Attachment 8 – Assessment of compliance with Design Guidelines– Precinct H.

Design Guidelines for Detached Housing – Precinct H

Beach and boardwalk access highlighted in green. Pedestrian access only.

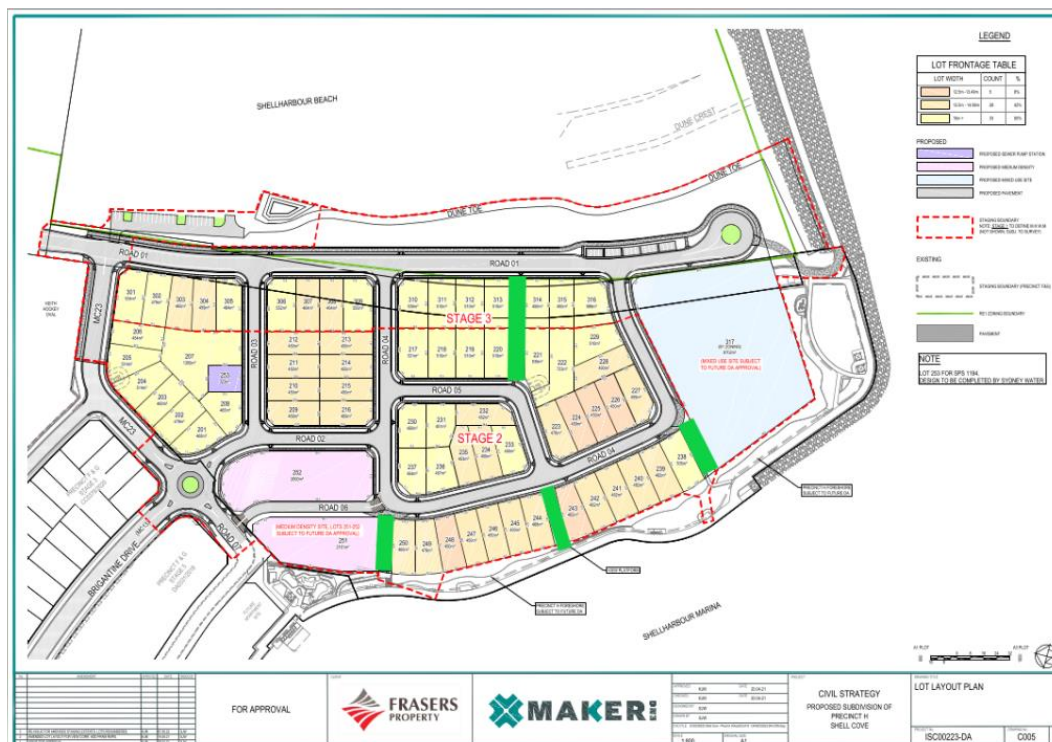
The subdivision layout proposed includes the visual and access corridors along the key east/west routes. Beach and boardwalk access is provided with additional visual links and breaks in built form.

Of the 66 lots proposed for detached housing, 31 are east/west (42%) With 20 lots west/east. Nine of the lots are north/south with the remainder (five) north/south.
